PI 1877
For technical personnel only!
1/1

PRODUCT INFORMATION

AUXILIARY WATER PUMP FOR AUDI A4/A5/A6/A7/A8/Q5

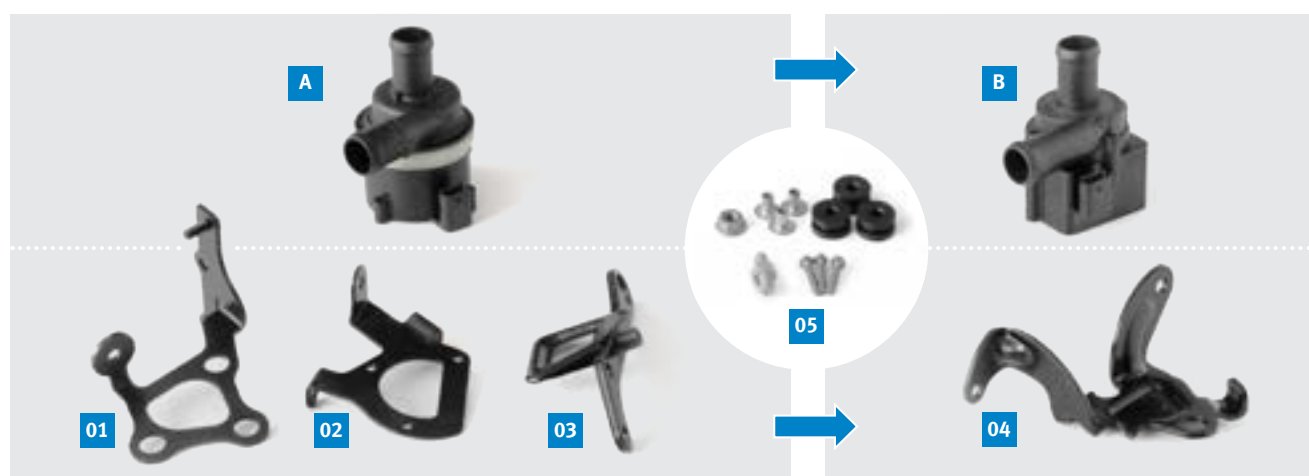
At the start of series production, the pump (A) with the ref no. 059 121 012 B was fitted. This pump was then replaced by a pump from Pierburg (ref. no. 06D 121 601) and a modified holder. The Pierburg pump prevents the problems that arose with the originally fitted series pump.

The pump 7.10102.05.0 (B) from Motorservice can be used to replace these pumps.

The original series pump (A) was supplied with three different holders (01), (02), (03) depending on the vehicle model. If the original series pump (A) is still installed in the vehicle, the separate holder (04) is required (not currently available from Motorservice). The fixtures (05) can be reused.
